Road Safety Audit Report

Proposed accesses off Hook Lane Aldingbourne

Client:
Bellamy Roberts

Report Title:	Stage 1 Road Safety Audit
Date:	December 2020
Document reference and revision:	RSA-20-145-4
Prepared by:	Fenley Road Safety Limited
On behalf of the Overseeing Organisation:	West Sussex County Council
Design Organisation:	Bellamy Roberts LLP
Project Sponsor:	Genesis Town Planning

Item Location Plan

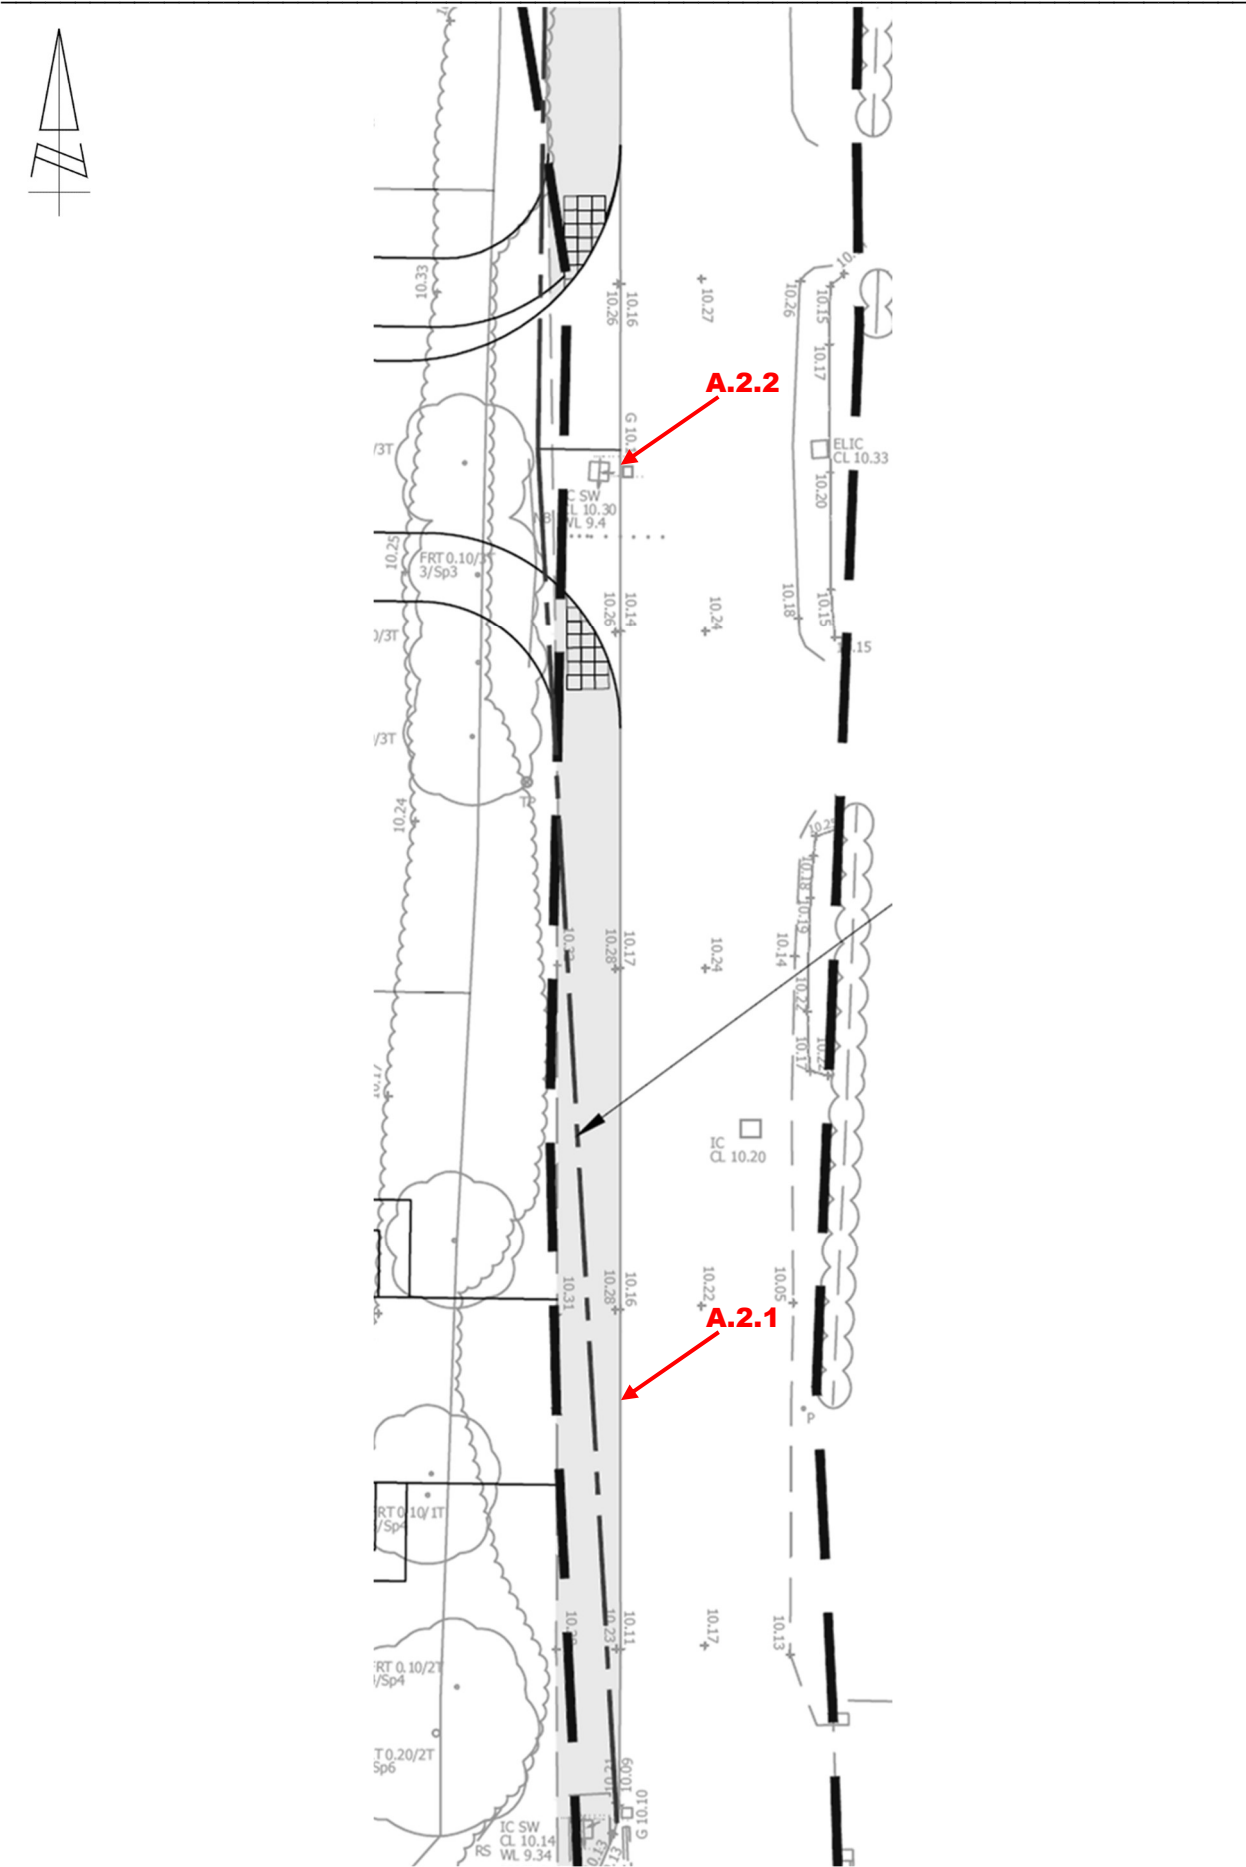
A.1	LOCAL ALIGNMENT
	<i>No Road Safety Concerns regarding LOCAL ALIGNMENT have been raised at this stage</i>
A.2	GENERAL
A.2.1	PROBLEM
Location:	Proposed vehicular crossover
Summary:	Full height kerbs will be an obstruction
Acc Type:	Vehicle loss of control
A footway has recently been provided along the Hook Lane site frontage as part of an adjacent development, that is bounded by full height kerbs alongside the carriageway and vegetation alongside the site. The proposals are to redevelop the application site to accommodate 10 dwellings with 8 accessed via a bell mouth and 2 via a vehicular crossover. The scheme drawing provided with the Audit Brief, does not identify that the kerbing at the proposed vehicular crossover is to be dropped. Full height kerbs at a vehicular access will be an obstruction and could give rise to loss of control type collisions.	
RECOMMENDATION:	
It is recommended that dropped kerbs are provided where necessary

A.2.2	PROBLEM
Location:	Proposed bellmouth access
Summary:	Existing road gully and inspection chamber are situated within the proposed access
Acc Type:	Vehicle loss of control
A footway has recently been provided along the Hook Lane site frontage as part of an adjacent development. As part of those works, a number of road gullies have been provided to cater for the surface water that would have previously drained to the soft verge that was present prior to the works. The proposals are to redevelop the application site to accommodate 10 dwellings with 8 accessed via a bell mouth and 2 via a vehicular crossover. The scheme drawing provided with the Audit Brief is based on a topographical survey that identifies that a gully and inspection chamber are present at the location of the proposed bellmouth, however, no notes highlight that the items are to be relocated. A road gully and cover situated within an access, are an obstruction and could give rise to loss of control type incidents particularly for two-wheeled vehicles.

Location Plan: 	
DESIGN ORGANISATION RESPONSE provided by Bellamy Roberts on the 23 rd December 2020 following formal issue of this Stage 1 Road Safety Audit on the 22 nd December 2020	
Accepted – The proposals are preliminary at this stage, dropped kerbs will be provided and identified at the detailed design stage.	
AUDITOR'S VIEW OF DESIGN ORGANISATION RESPONSE dated 23 rd December 2020	
Confirmation that dropped kerbs will be provided, addresses the road safety concern raised at this stage.

RECOMMENDATION:	
It is recommended that gully and associated inspection chamber are relocated	
Location Plan: 	
DESIGN ORGANISATION RESPONSE provided by Bellamy Roberts on the 23 rd December 2020 following formal issue of this Stage 1 Road Safety Audit on the 22 nd December 2020	
Accepted – The proposals are preliminary at this stage, the existing surface water drainage network will be assessed at the detailed design stage and upgraded if necessary.	
AUDITOR'S VIEW OF DESIGN ORGANISATION RESPONSE dated 23 rd December 2020	
Confirmation that the gully will be relocated, addresses the road safety concern raised at this stage.	
A.3	JUNCTIONS
	No Road Safety Concerns regarding JUNCTIONS have been raised at this stage
A.4	WALKING CYCLING AND HORSE RIDING
	No Road Safety Concerns regarding WALKING CYCLING AND HORSE RIDING have been raised at this stage
A.5	ROAD SIGNS, CARRIAGEWAY MARKINGS AND LIGHTING
	No Road Safety Concerns regarding ROAD SIGNS, CARRIAGEWAY MARKINGS AND LIGHTING have been raised at this stage
